HISTORIC AND DESIGN REVIEW COMMISSION

November 20, 2019

HDRC CASE NO: 2019-640
ADDRESS: 218 W WOODLAWN
LEGAL DESCRIPTION: NCB 1859 BLK 2 LOT 7
ZONING: R-4,H
CITY COUNCIL DIST.: 1
DISTRICT: Monte Vista Historic District
APPLICANT: E.C. Parker
OWNER: Dave Isaacs
TYPE OF WORK: Roofline modifications
APPLICATION RECEIVED: October 18, 2019
60-DAY REVIEW: December 17, 2019
CASE MANAGER: Stephanie Phillips
REQUEST:

The applicant is requesting a Certificate of Appropriateness for approval to modify the existing roofline of the historic 1-story structure to include the modification of two existing side dormers and the installation of a new front dormer. All three dormers will feature one over one wood windows.

A3.1

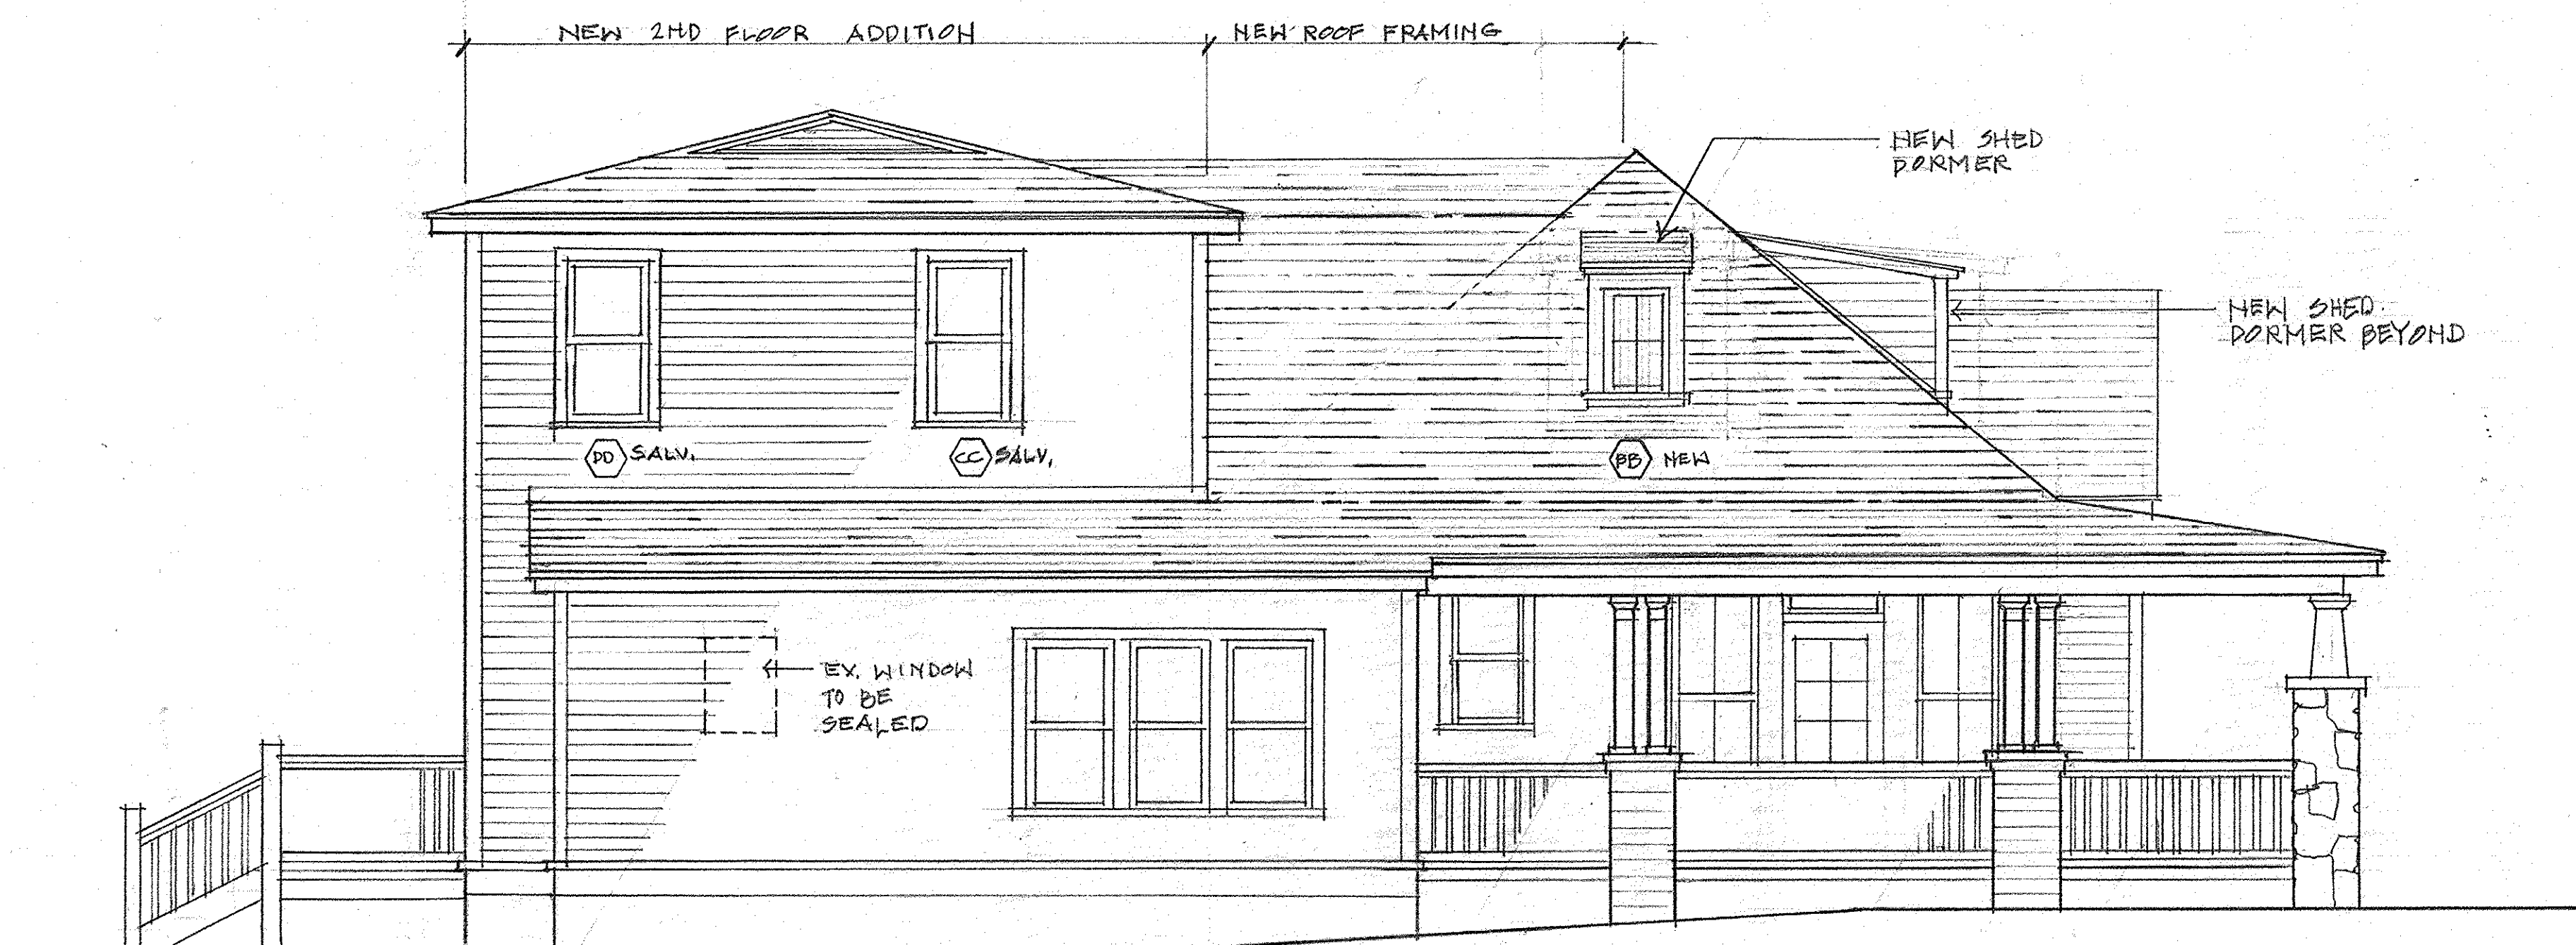
- c. **ROOFLINE MODIFICATIONS TO EXISTING STRUCTURE** – The applicant has proposed to modify the existing roofline of the primary 1-story historic structure. Modifications include increasing the height of the existing dormers facing south and east to accommodate new wood windows and adding a new dormer on the front-facing roofline to match. According to the Historic Design Guidelines, distinctive roof features, such as cornices, parapets, dormers, open eaves with exposed rafters and decorative or plain rafter tails, flared eaves or decorative purlins, and brackets, should be preserved and repaired. Staff does not find the dormer modifications or the addition of a new dormer on the front façade appropriate for the historic structure.

Staff does not recommend approval of the dormer modifications and new front dormer installation on the front façade of the primary historic structure based on finding c. Staff recommends that the existing roofline and dormers be retained.

- i. That the applicant submits a final window specification for the proposed wood windows to staff for review and approval. Meeting rails must be no taller than 1.25" and stiles no wider than 2.25". There should be a minimum of two inches in depth between the front face of the window trim and the front face of the top window sash. This must be accomplished by recessing the window sufficiently within the opening or with the installation of additional window trim to add thickness. Window trim must feature traditional dimensions and architecturally appropriate sill detail. Window track components must be painted to match the window trim or concealed by a wood window screen set within the opening.
